COMMENT LETTER

TEN TRIBES PARTNERSHIP COMMENTS
COLORADO RIVER INTERIM SURPLUS CRITERIA
DRAFT ENVIRONMENTAL IMPACT STATEMENT

Figure 1. Different combinations of Tribal Accounting Pool (TAP) and contents of Lake Mead relative to surplus (+) and shortage (-) trigger elevations.

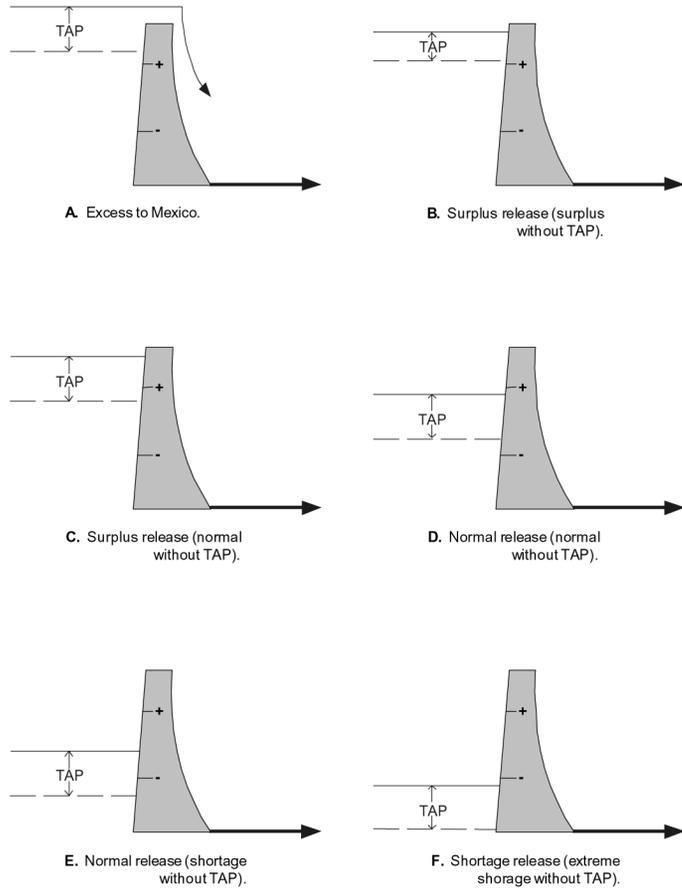
Figure 3a shows a relatively large amount (nearly 80 KAF annually) of TAP water going to realize surplus deliveries (TAP condition shown in Figure 1c) under the California, Six State, and Shortage Protection Alternatives and a modest amount (17 KAF annually under the No Action Alternative during the interim period. Small amounts of TAP water also go to normal (TAP condition shown in Figure 1e) and extreme shortage relief (TAP condition shown in Figure 1f).

During the post-interim period over 40 KAF annually of TAP water goes to extreme shortage relief and a near equal amount to meet normal deliveries under all surplus alternatives. With exception of the Flood Control Alternative there is little difference in TAP releases among the alternatives during the post-interim period. Note that for the Flood Control Alternative there is never any surplus TAP release (TAP condition shown in Figure 1c) since under this alternative surplus is coincidental with the condition shown in Figure 1a when the TAP is reset.
